SUBJECT: Forwards addl info re near-term completion of Item 4.3,
 "Reactor Trip Sys Reliability" of Generic Ltr 83-28 &
 addresses 13 items listed in final SER on shunt trip design.

Re: Docket No. 50-275, OL-DPR-76
Docket No. 50-323
Diablo Canyon Units 1 and 2
GL No. 83-28 - Generic Implications of ATWS Events
Item 4.3 "Reactor Trip System Reliability"

SHUNT TRIP MODIFICATION

8312280416-01
DC-663197-33-2

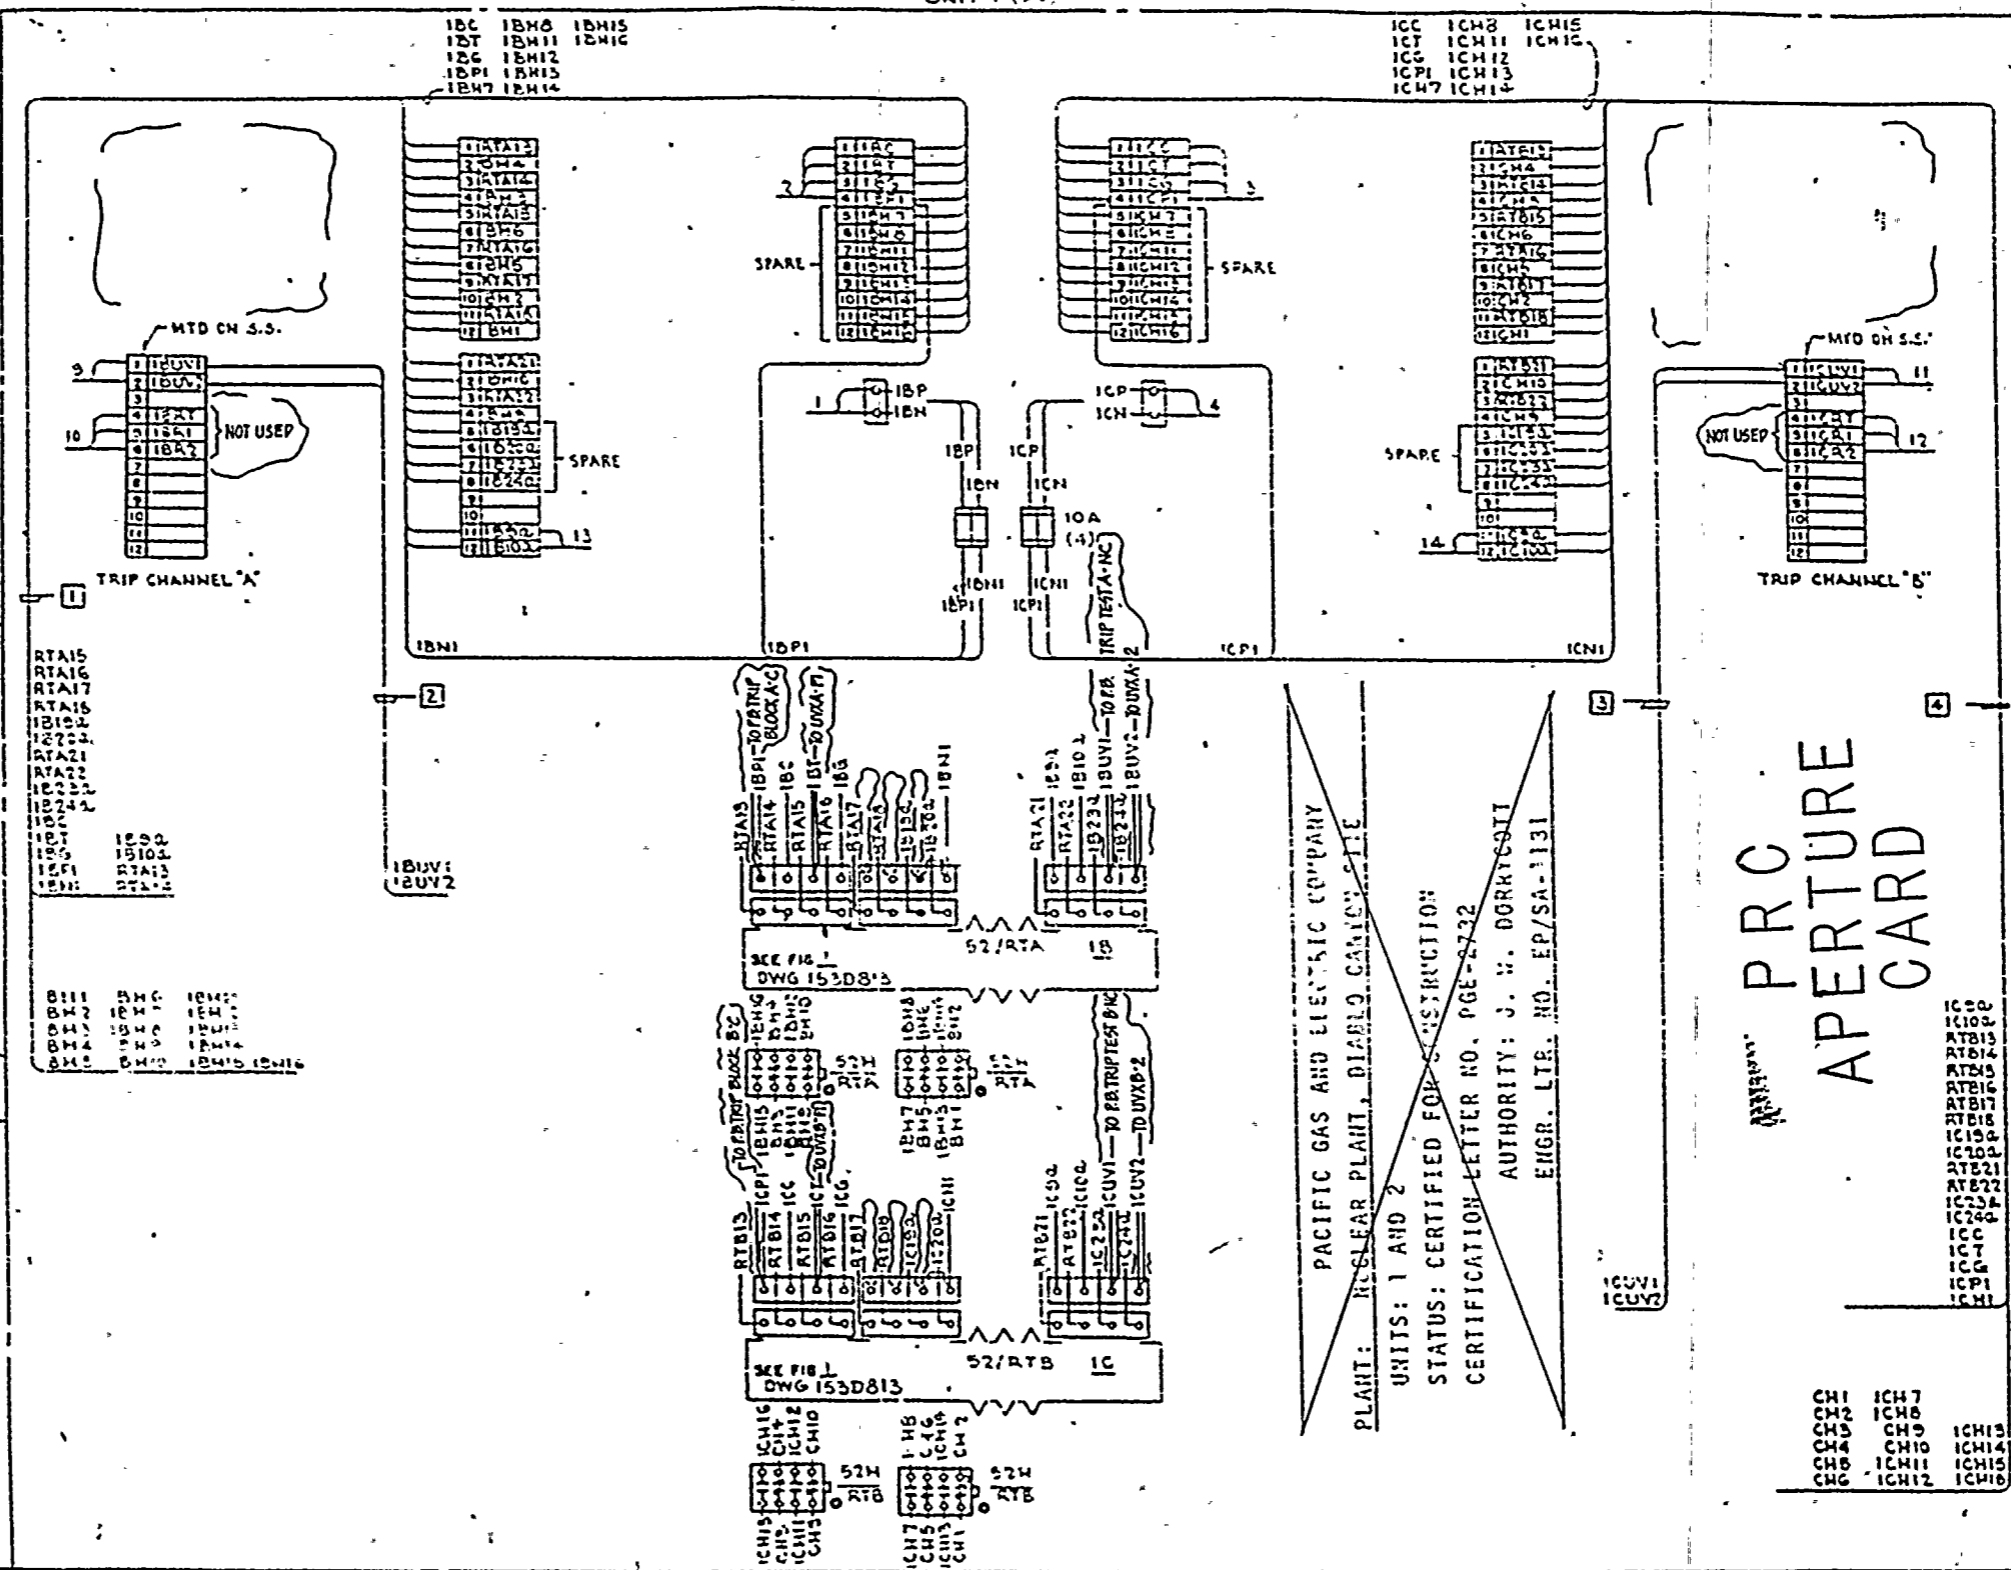
"Provide the electrical schematic/elementary diagrams for the reactor trip and bypass breakers showing the undervoltage and shunt coil actuation circuits as well as the breaker control (e.g., closing) circuits, and circuits providing breaker status information/alarms to the control room."

"Identify the power sources for the shunt trip coils. Verify that they are Class 1E and that all components providing power to the shunt trip circuitry are Class 1E and that any faults within non-Class 1E circuitry will not degrade the shunt trip function. Describe the annunciation/indication provided in the control room upon loss of power to the shunt trip circuits. Also describe the overvoltage protection and/or alarms provided to prevent or alert the operator(s) to an overvoltage condition that could affect both the UV coil and the parallel shunt trip actuation relay."

Attached are electrical drawings for the reactor trip and bypass breakers showing the undervoltage and shunt coil actuation circuits as well as the breaker control (e.g., closing) circuits, and circuits providing breaker status information/alarms to the control room.

The power supplies and all components providing power to the shunt trip circuitry are Class 1E. No change has been made to the power supply portion of the circuitry. Drawing No. SK437610 Rev. 9B shows the power supply for the shunt trip coil of 52/RTA is from Battery 11 thru CKT 129D. The power supply for 52/RTB is from Battery 12 via CKT 229D. Since the Class 1E circuitry provided to the shunt trip is separated from non-Class 1E circuitry, a fault within non-Class 1E circuitry will not degrade the shunt trip function.
